Tognum America Headquarters SP 11-22

Consideration of the request of Northern Equities Group for Preliminary Site Plan and Stormwater Management Plan approval. The subject property is located at 39525 Mackenzie Drive, at the southwest corner of Mackenzie Drive and Haggerty Road, north of Thirteen Mile Road, in Section 1 of the City. The property totals 7.02 acres and the applicant is proposing a 68,475 square foot building with associated parking and landscaping.

PLAN REVIEW CENTER REPORT

ENGINEERING REVIEW

Standard Parking Island Design with minimum 8' width

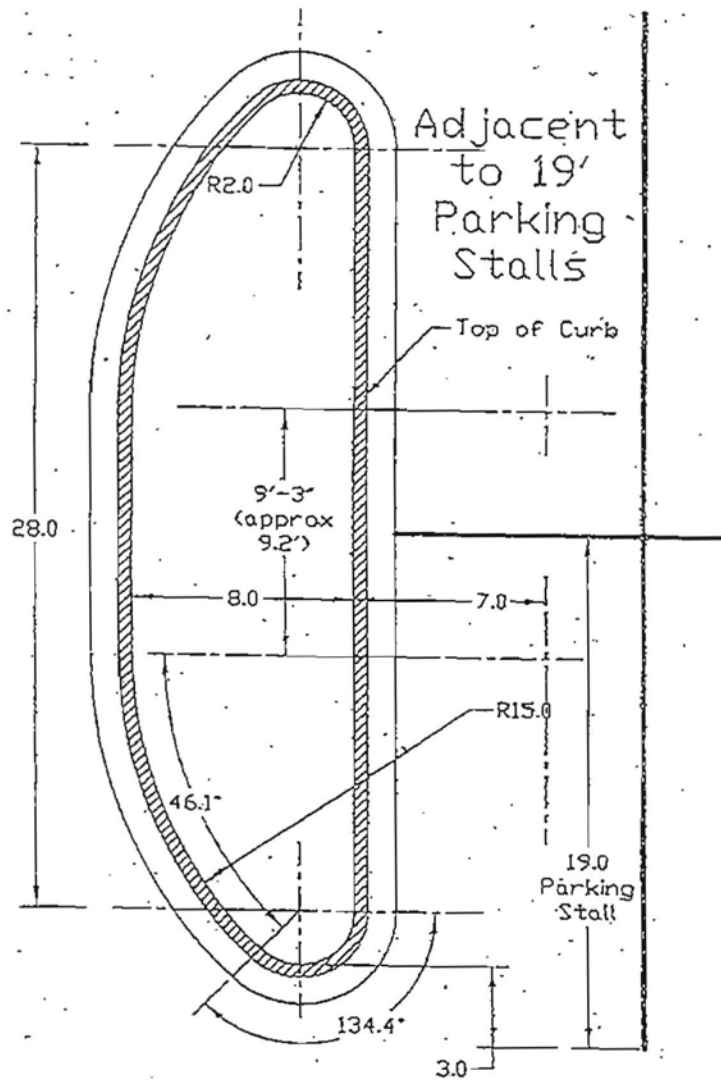
13. A raised end island can (and should) be provided in the preceding location without losing any parking spaces, since three components of the proposed design are wider than necessary: (a) The west end aisle scales 26 ft wide, or 2 ft above standard; (b) The adjacent raised end island scales 13 ft wide (back-to-back), or 5 ft above standard (see attached detail); and (c) the east end aisle is dimensioned 30.5 ft wide, or 6.5 ft above standard. **With a total of 13.5 ft in total savings, it should be a relatively easy matter of inserting an 8-ft-wide raised end island at the east end of this parking module.**

24. The intended design was for a 4-inch curb, the note has been corrected.
25. All islands have been modified to comply with both this comment and the comments in the Traffic review.
